My name is Samuel Miranda. I submitted the enforcement petition that is under your review. It is submitted under the terms of 10 CFR §2.206, and it concerns the licensing and operation of the Byron and Braidwood Stations.

I maintain that Exelon, has obtained the NRC's authorization to operate its Byron and Braidwood Stations at an uprated power level, without demonstrating that its plant designs meet all design requirements, specified in their licensing bases. I am requesting, among other things, that the NRC revoke its uprating approvals, and compel Exelon to operate its Byron and Braidwood Stations at their originally licensed power levels until the required demonstration of compliance is made. The petition describes several issues, in Exelon's LAR and in its licensing basis, that support this request.

Figure 1
AOO Boundary

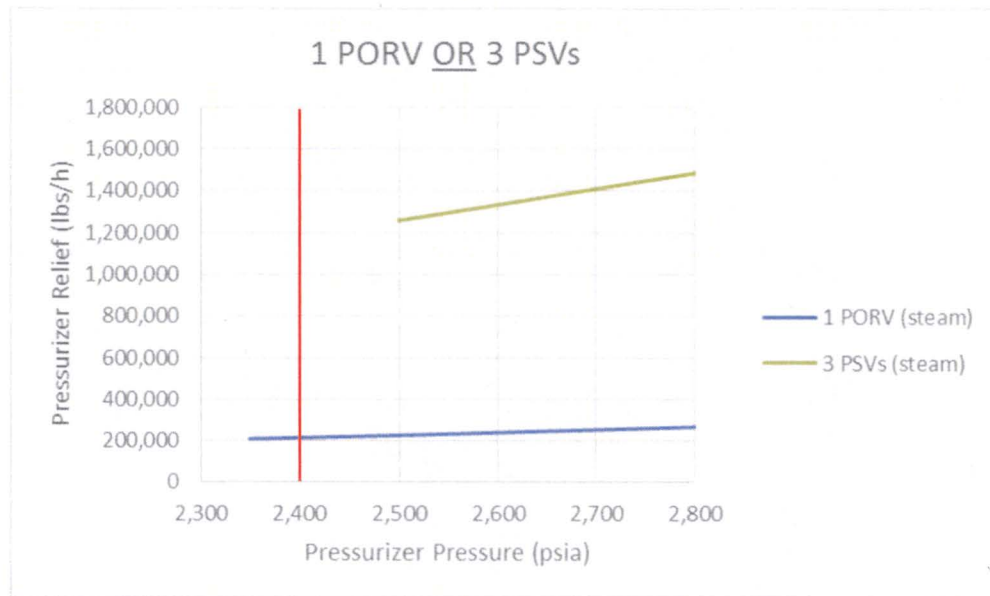
- One PORV is shown to open at 2,350 psia. This is enough to prevent the opening of any PSVs.
- The high pressure reactor trip (marked in red) will occur when pressure exceeds 2,400 psia.

- The PSV opening setpressure is higher than the pressure boundary that defines an AOO (i.e., the 2,400 psia reactor high pressure trip setpoint).
- If pressure continues to increase, after the reactor is tripped, and a PORV does not open, then one or more PSVs would open at 2,500 psia (set to the RCS design pressure).

- Pressure relief would be provided by the PORVs or by the PSVs; but not both.
- Three PSVs have more than six times the steam relief capacity of one PORV.

- AOOs would lie to the left of the red reactor trip line (i.e., pressures below 2,400 psia). If pressure exceeds the reactor trip setpoint (i.e., despite the reactor shutdown), then the reactor shutdown has not accommodated the event. Consequently, the event is not an AOO. So events that lie to the right of the red line are not AOOs. If these events are not AOOs, then they must be Condition III or IV events.

- PSVs cannot open until after the AOO becomes a more serious event (i.e., opening of the PSVs cannot meet the *non-escalation requirement*).

The high pressure reactor trip setpoint is 2400 psia. The opening setpoint of the PSVs is 2500 psia. Therefore, the PSVs will not open until after the event will have progressed beyond the defining boundary of an AOO. The event is no longer an AOO. Therefore, it must be a Condition III event. Worse, it is a Condition III event with the frequency of occurrence of an AOO. Worse still, the frequency of occurrence will be the sum of the frequencies of occurrence of all AOOs that pressurize the RCS to the opening setpressure of the PORVs.

Exelon's compliance strategy, which prevents the PORVs from opening, allows the RCS pressure to exceed (by 100 psi) the reactor trip setpoint in order to open the PSVs. This pressure level is beyond the defining boundary of an AOO. Therefore, it becomes necessary to generate a more serious plant condition in order to open any of the PSVs. In this respect, Exelon begs the question. In other words, Exelon claims that certain ANS Condition II events must be allowed to progress to more serious ANS Condition III events in order to demonstrate that those ANS Condition II events will not progress to more serious ANS Condition III events!

Figure 2
Flow in ≠ Flow out

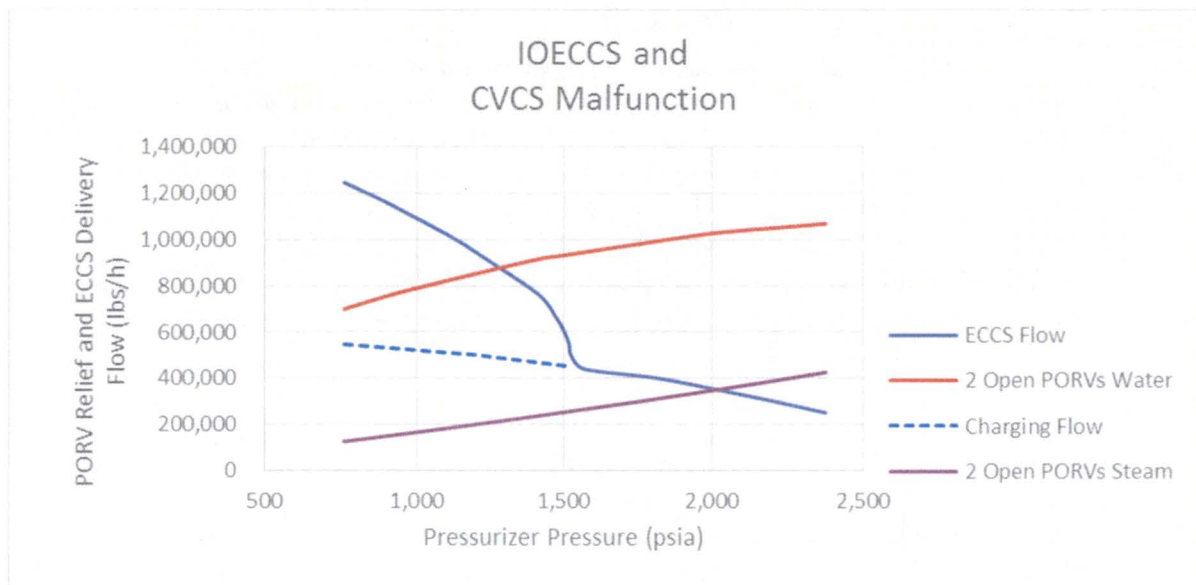
Since the cause of the water relief is the ECCS flow, the magnitude of the leak will be less than or equivalent to that of the ECCS (i.e., operation of the ECCS maintains RCS inventory during the postulated event and establishes the magnitude of the subject leak).

- (1) ECCS (i.e., charging) flow rate will not exceed the PORV steam relief rate until the RCS pressure drops to about 2,000 psia,
- (2) ECCS flow rate will not exceed the PORV water relief rate until the RCS pressure drops to about 1,300 psia, and
- (3) Charging flow rate will not exceed the PORV water relief rate until the RCS pressure drops below the accumulator injection setpoint (about 600 psia).
- (4) One PSV has about twice the steam relief capacity of a PORV, and there are three of them. To estimate the steam relief rate of three stuck-open PSVs, triple the depicted steam relief rate of two stuck-open PORVs.

The pressurizer, during mass addition AOs (e.g., IOECCS and CVCS Malfunction), is not an open system, like a bucket that is running over. It is a closed, pressurized system with a hole in it. The flow exiting through the hole is determined by the size of the hole, and the pressure of the system, not by the flow that may be entering the system. The NSAL's *mass-balance* argument (i.e., what goes in, comes out) contradicts the basic principles of fluid mechanics. Exelon has adopted this rationale, and copied it into its license amendment requests (LARs), and submitted it to the NRC under Oath and Affirmation.

Figure 1
AOO Boundary

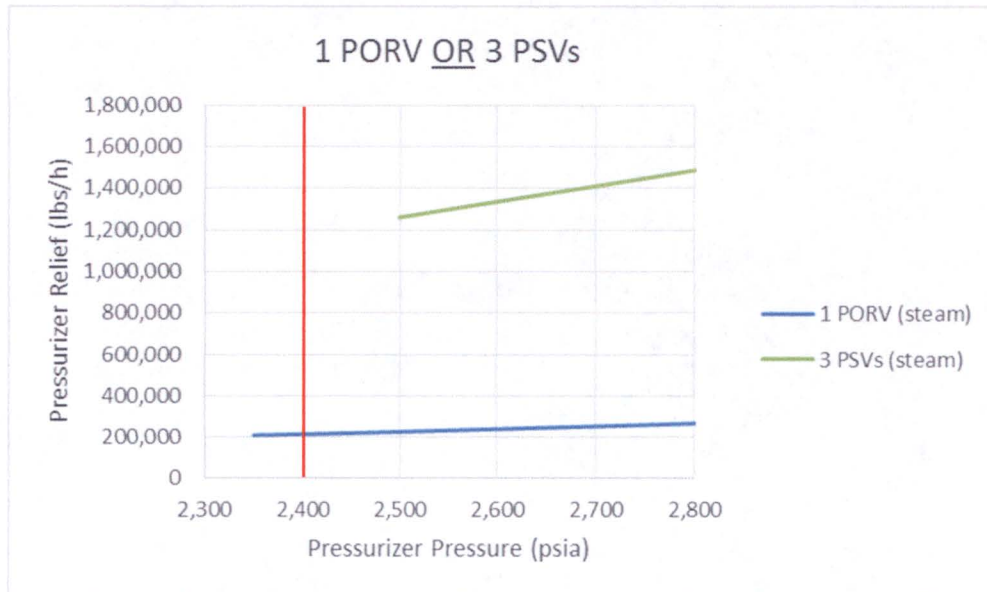
- One PORV is shown to open at 2,350 psia. This is enough to prevent the opening of any PSVs.
- The high pressure reactor trip (marked in red) will occur when pressure exceeds 2,400 psia.

- The PSV opening setpressure is higher than the pressure boundary that defines an AOO (i.e., the 2,400 psia reactor high pressure trip setpoint).
- If pressure continues to increase, after the reactor is tripped, and a PORV does not open, then one or more PSVs would open at 2,500 psia (set to the RCS design pressure).

- Pressure relief would be provided by the PORVs or by the PSVs; but not both.
- Three PSVs have more than six times the steam relief capacity of one PORV.

- AOOs would lie to the left of the red reactor trip line (i.e., pressures below 2,400 psia). If pressure exceeds the reactor trip setpoint (i.e., despite the reactor shutdown), then the reactor shutdown has not accommodated the event. Consequently, the event is not an AOO. So events that lie to the right of the red line are not AOOs. If these events are not AOOs, then they must be Condition III or IV events.

- PSVs cannot open until after the AOO becomes a more serious event (i.e., opening of the PSVs cannot meet the *non-escalation requirement*).

Figure 2
Flow in \neq Flow out

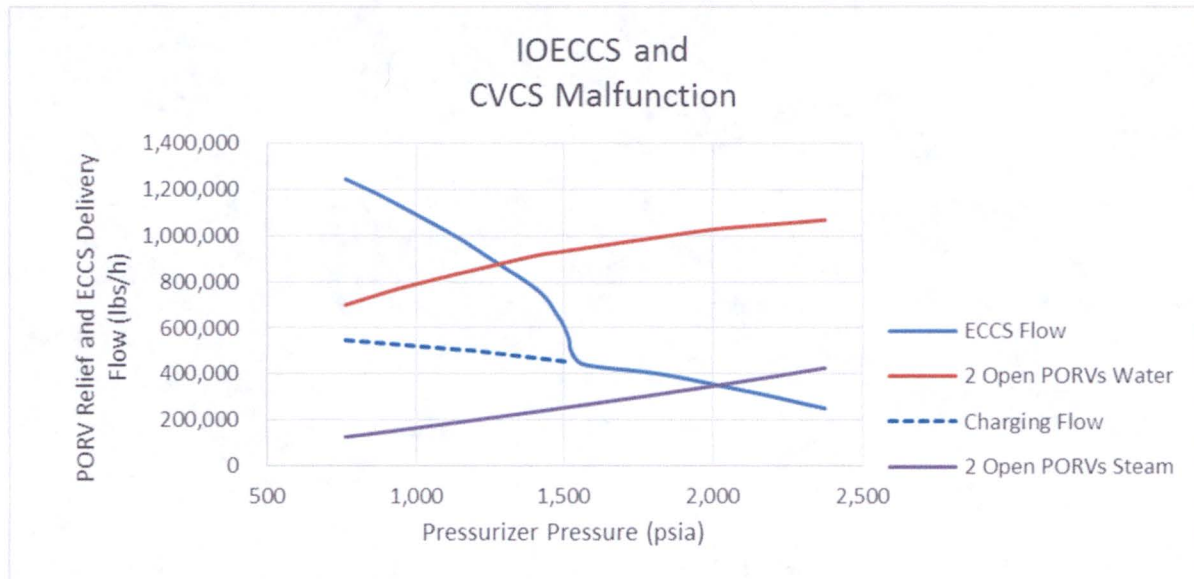
Since the cause of the water relief is the ECCS flow, the magnitude of the leak will be less than or equivalent to that of the ECCS (i.e., operation of the ECCS maintains RCS inventory during the postulated event and establishes the magnitude of the subject leak).

- (1) ECCS (i.e., charging) flow rate will not exceed the PORV steam relief rate until the RCS pressure drops to about 2,000 psia,
- (2) ECCS flow rate will not exceed the PORV water relief rate until the RCS pressure drops to about 1,300 psia, and
- (3) Charging flow rate will not exceed the PORV water relief rate until the RCS pressure drops below the accumulator injection setpoint (about 600 psia).
- (4) One PSV has about twice the steam relief capacity of a PORV, and there are three of them. To estimate the steam relief rate of three stuck-open PSVs, triple the depicted steam relief rate of two stuck-open PORVs.

The pressurizer, during mass addition AOOs (e.g., IOECCS and CVCS Malfunction), is not an open system, like a bucket that is running over. It is a closed, pressurized system with a hole in it. The flow exiting through the hole is determined by the size of the hole, and the pressure of the system, not by the flow that may be entering the system. The NSAL's *mass-balance* argument (i.e., what goes in, comes out) contradicts the basic principles of fluid mechanics. Exelon has adopted this rationale, and copied it into its license amendment requests (LARs), and submitted it to the NRC under Oath and Affirmation.
